UNITED STATES PATENT AND TRADEMARK OFFICE

Office Action Summary

10/695,011

BAUER, VAUGHN L.

FIG. 3

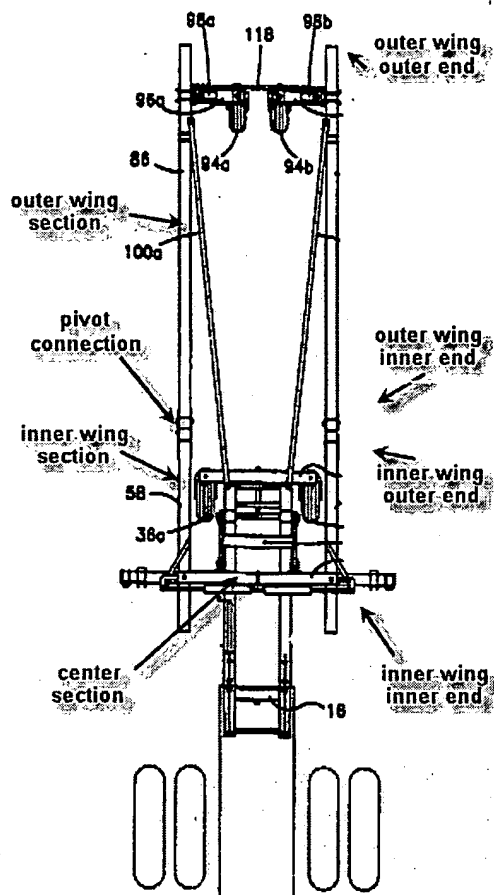
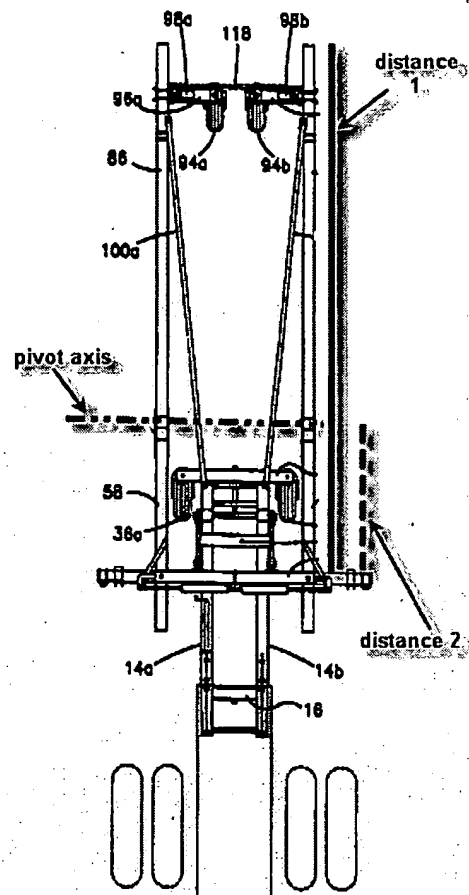
Kirwan discloses a forwardly folding toolbar comprising a tongue, a center section, outer wing sections, inner wing sections, with a distance between the outer end of the outer wing section and the inner end of the inner wing section greater than a distance between the inner end of the outer wing section and the inner end of the inner wing section. Concerning the method claims, given the structure of Kirwan, the claimed method steps would inherently be performed while the device of Kirwan was assembled and operated. Concerning the claimed actuators, figure 8 discloses the use of actuators

for raising the pivot points relative to the ground engaging wheels. Concerning the claimed latch, transport securement bar 118 is considered a latch.

distance 1 > distance 2
